**DOCUMENT 00 91 13.02
ADDENDUM NO. 2**

Project: Pawtucket Scope B **Project No.** 12014.02

Date: March 4, 2014

BOILER ROOM DEMO & NEW PART PLANS & SCHEDULES

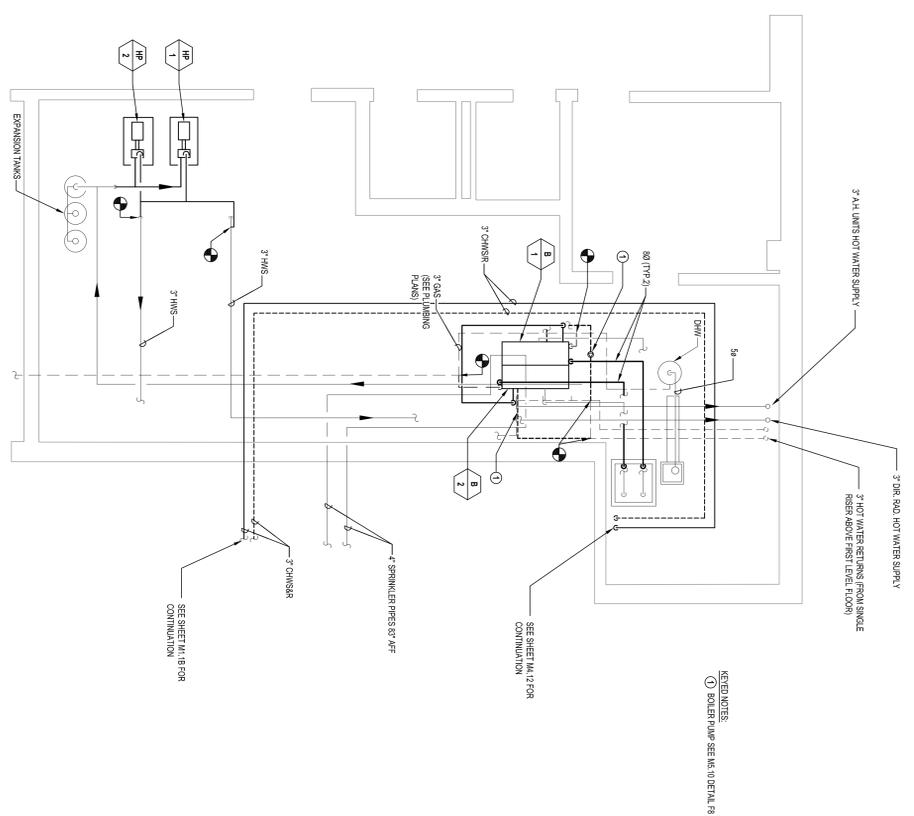
Alternate Learning Program: On Dwg M4.11 it shows two 811 lines which I assume to be flues (no label) rising up inside the existing chimney. How do we support the flues inside the chimney? No support detail provided. How do you gain access to the inside of the chimney? How high is the chimney to the roof cap? How do we terminate the flue? Where are the combustion air pipes for the boilers? Not shown on the drawings.

E7 CHILLER CONTROLS DIAGRAM
NTS

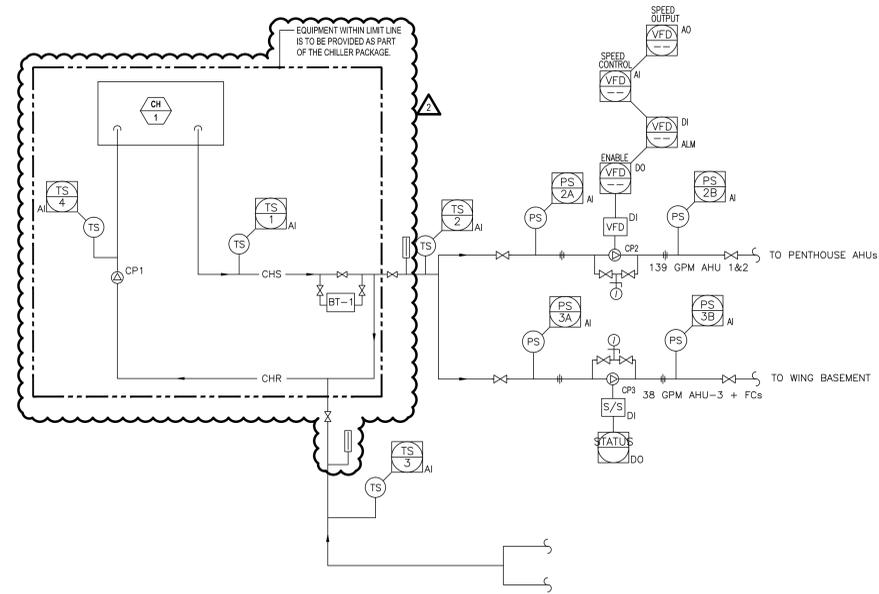
Alternate Learning Program: There is no chiller piping detail indicating any isolation valves, flow switches, temp gauges, strainers, flex connections at the chiller. Do you require them?

- *Additional non-control valves and gauges have been added to the controls/schematic diagram to clarify this.*
-

**FIRST FLOOR
PLAN**

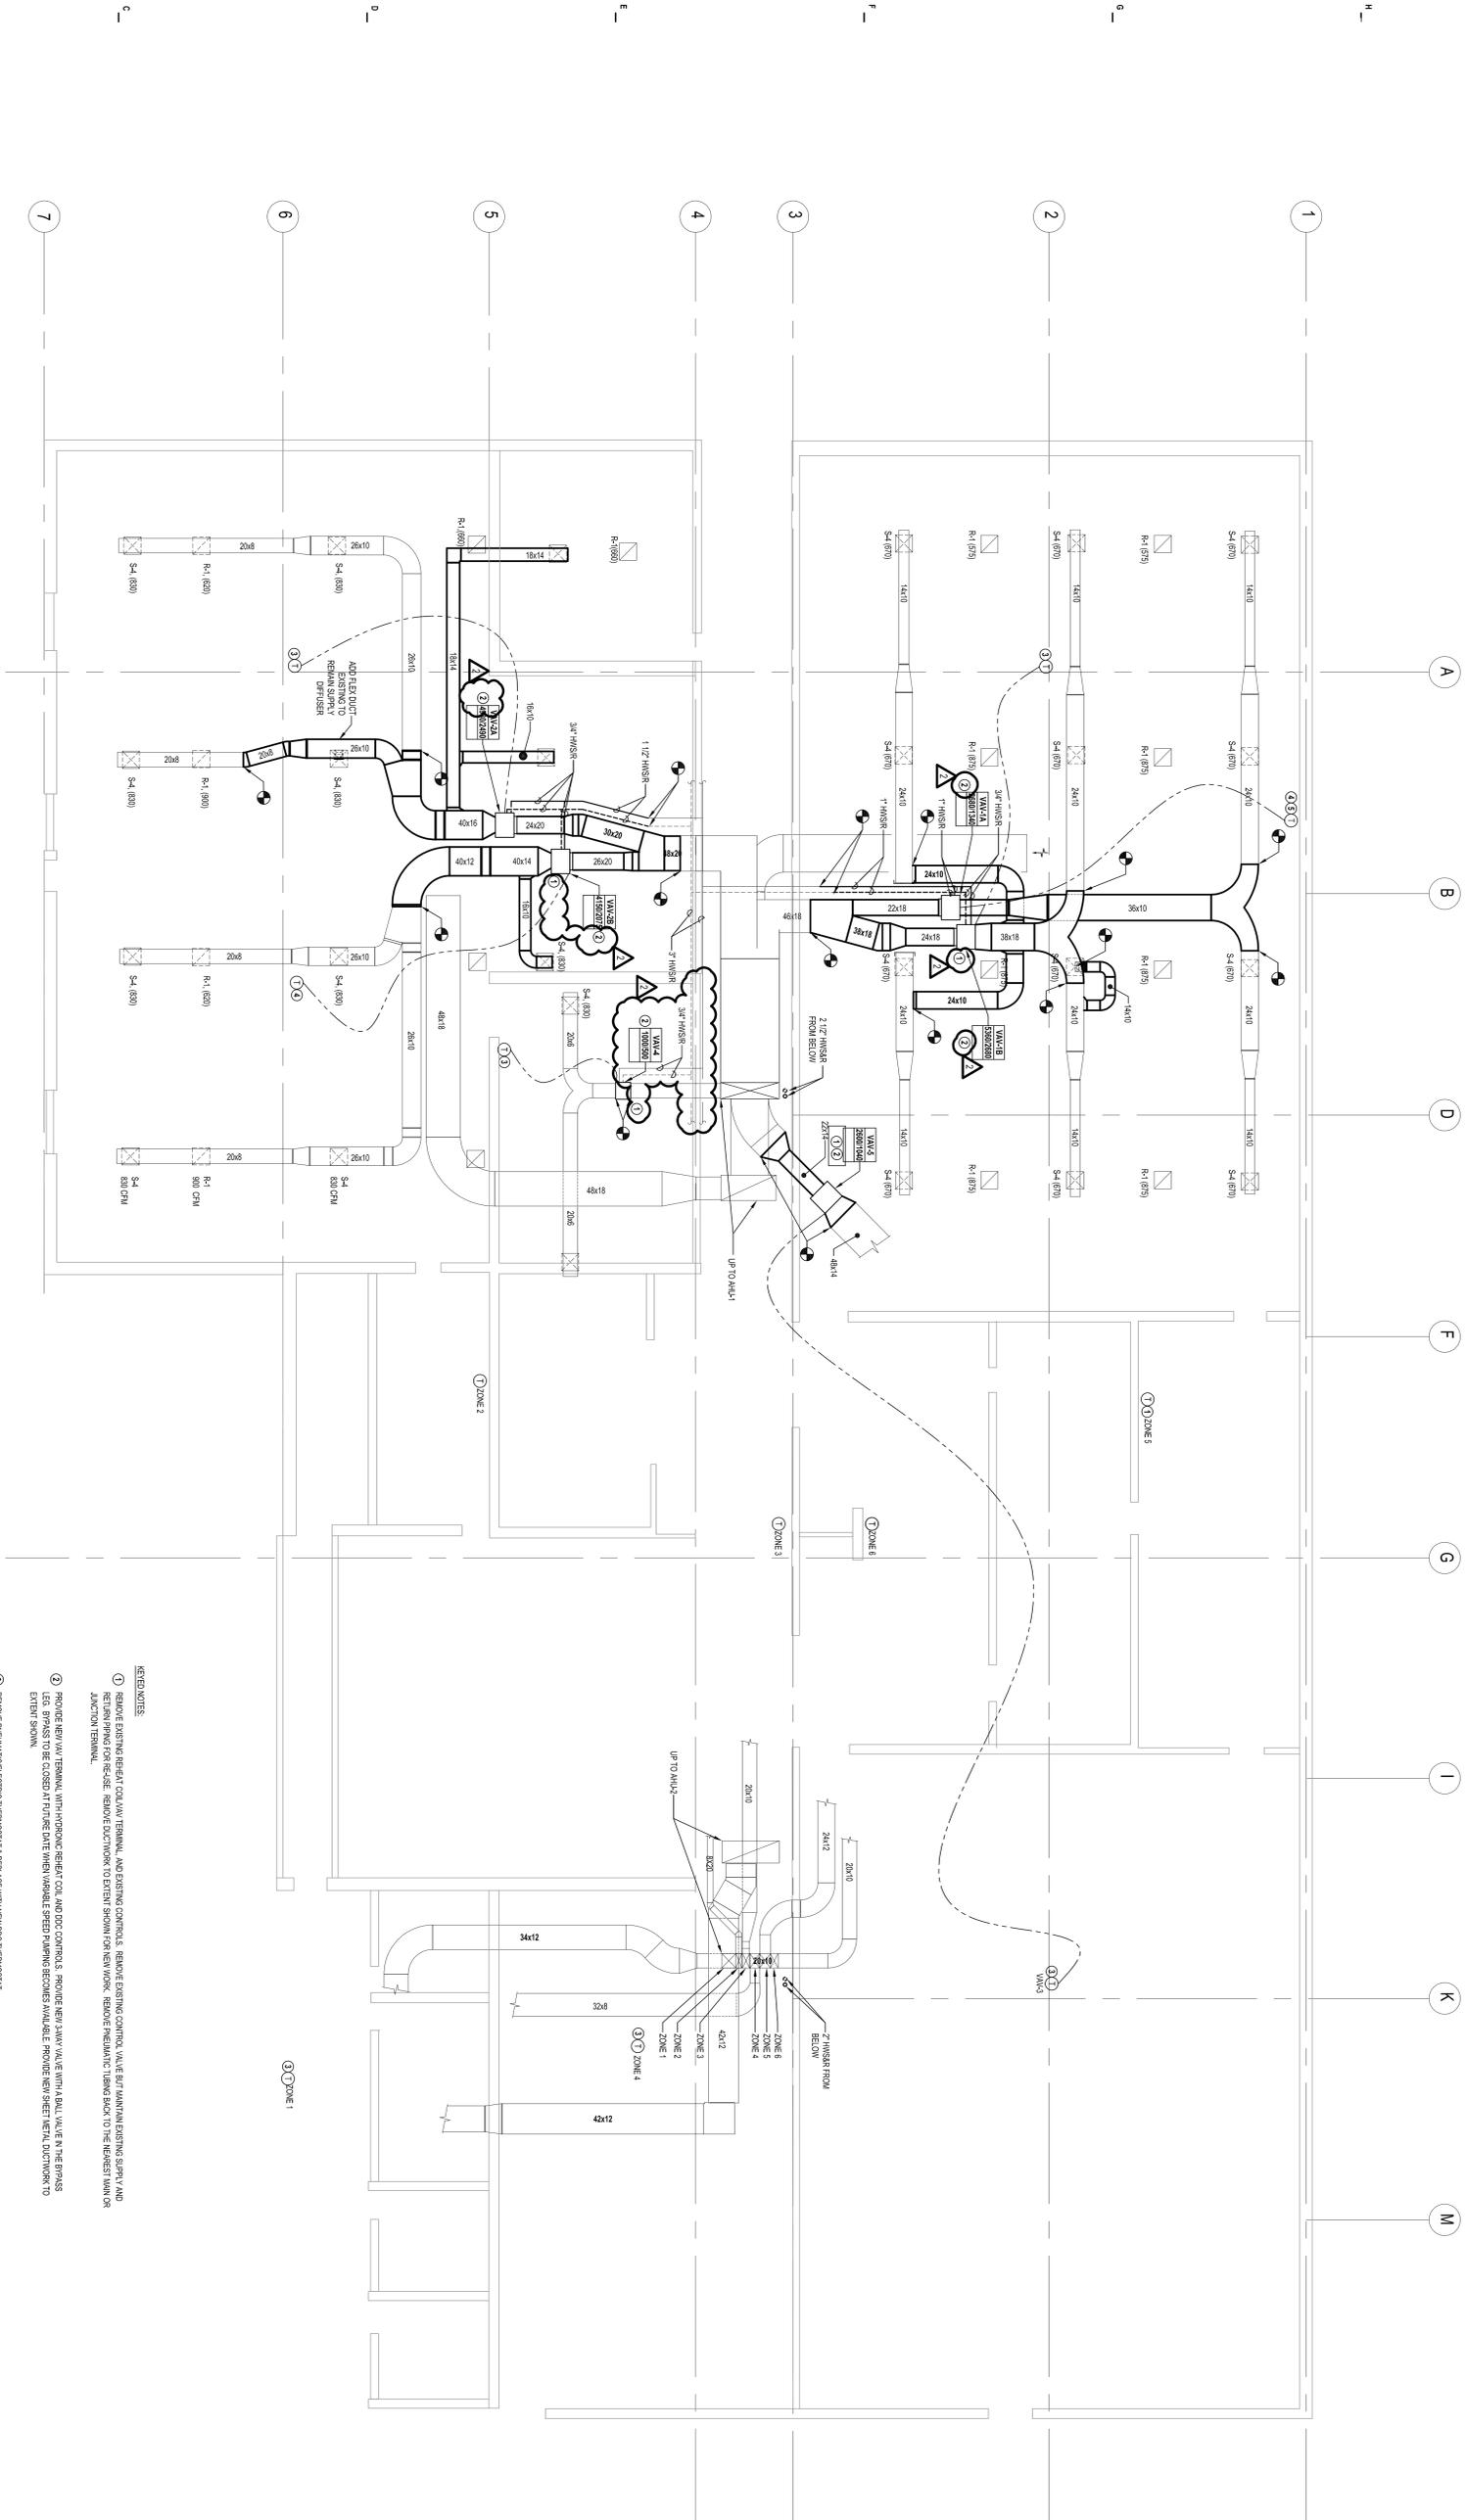
Elizabeth Baldwin Elementary School: On Dwg.Ml.21 it doesn't show any hot water piping going to the vav#4. What size is it and where do I connect the new piping to the existing lines.
